Document Number: **HEMCG2-2539**
Date: June 16, 2015

Safety Certification Change Notice

Safety Standard Certified Chip Capacitors GA3 Series (Type GD)

Before Change	After Change

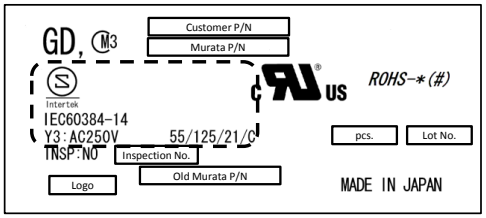
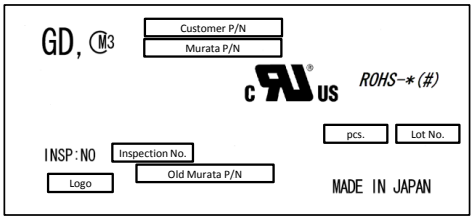
3. Change of label:

With the de-certification of Class Y3, we will change the label as shown below after April 2016.
